Superseded B376R1077-0

Number: B61-0217-00

Ride: YO YO

Subject SWEEP CYLINDER

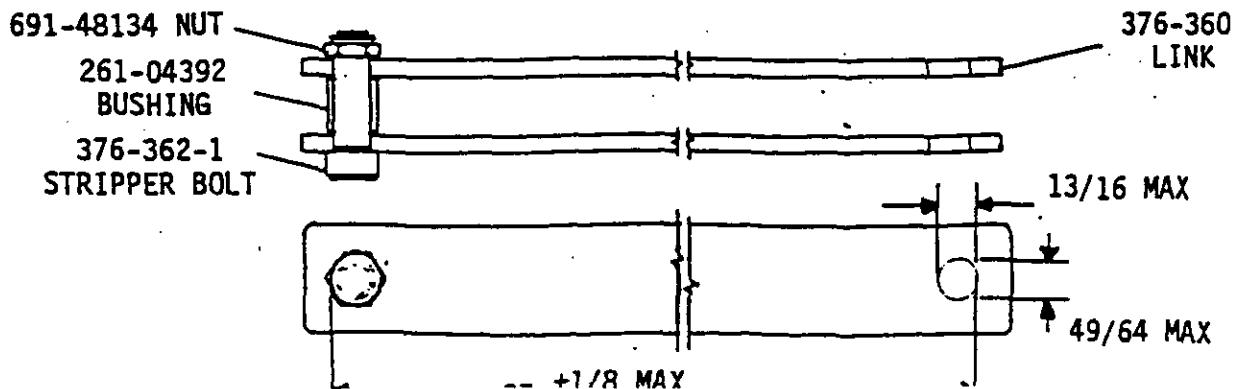
1. Starting with the ride erected and the sweeps folded against the tower, remove the seats and "T" bars.
2. Disconnect the bar linkage stripper bolts at the sweeps. Select two linkage bars 180° apart and connect them together at the top with a stripper bolt, for use as a pick up. Bundle the remaining bars together with a rope.
3. Remove the 1" bolts, nuts and lockwashers holding the cylinder in the ride. Retract the cylinder rod by engaging the raise switch, stopping the retraction about 6" short of full retract.
4. Remove hoses from cylinder, and cap all open hoses and fittings. Remove handle from valve at base of cylinder and turn all fittings against the side of the cylinder body for removal clearance through the mounting hole.
5. Select a mobile crane with a capacity of 1500 pounds at boom angle and elevation as illustrated for removal of the cylinder.

6. Raise cylinder out of the top of the ride, observing clearance of plumbing, through mounting hole, as it is removed. Lower cylinder to a pallet on the ground, protecting the plumbing and bar linkage as it is being placed onto the pallet.
7. Remove bar linkage from spider and inspect all stripper bolts and steel bushings for wear. Holes in bar linkage should not be elongated more than shown on illustration.

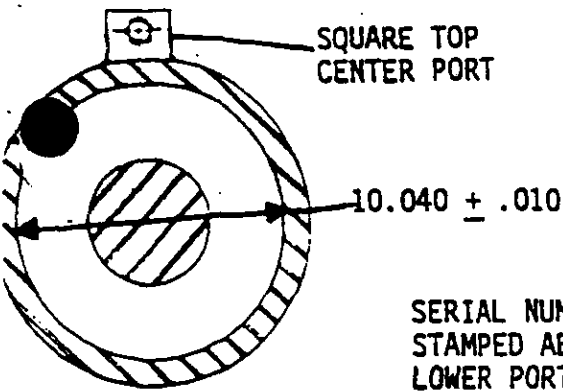
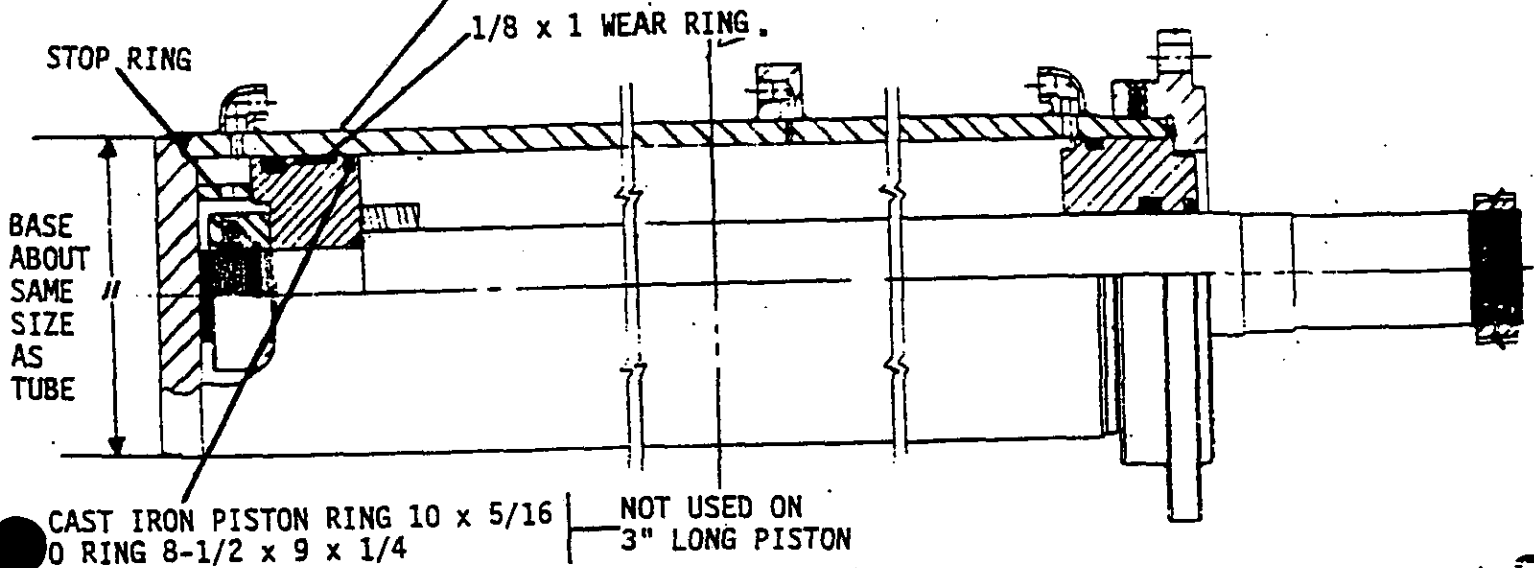
1. A competent third party hydraulic organization must be selected for disassembly and pressure testing of the cylinder.
2. Identification of the cylinder as to original Manufacturer is necessary to order the proper seal kits or other repair parts. Exterior examination will identify the cylinder as follows:

Hydraulic organization shall identify cylinder as above and fill out portion of Chance form dealing with identification, bore, stop ring, stroke measurement and pressure tests. Failure of cylinder to meet any of the required dimensions or tests, will require return to Chance Manufacturing Co., Inc. for five (5) year rod replacement and reconditioning.

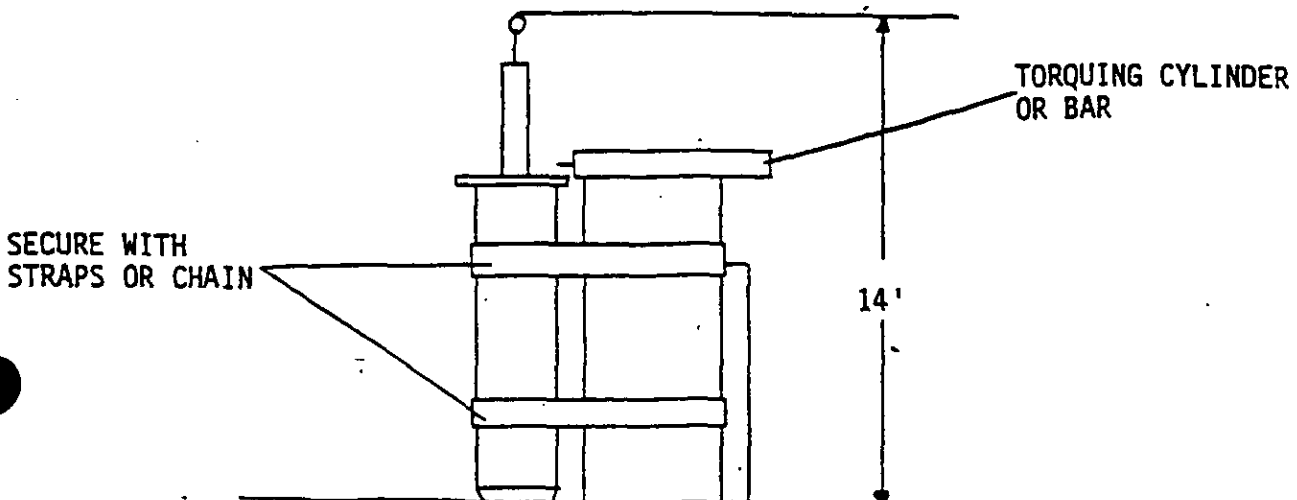
3. Secure the cylinder, in an upright position, in a stand capable of supporting the cylinder and torquing the cap as illustrated below. 14 ft. head room for removal of the rod is required.
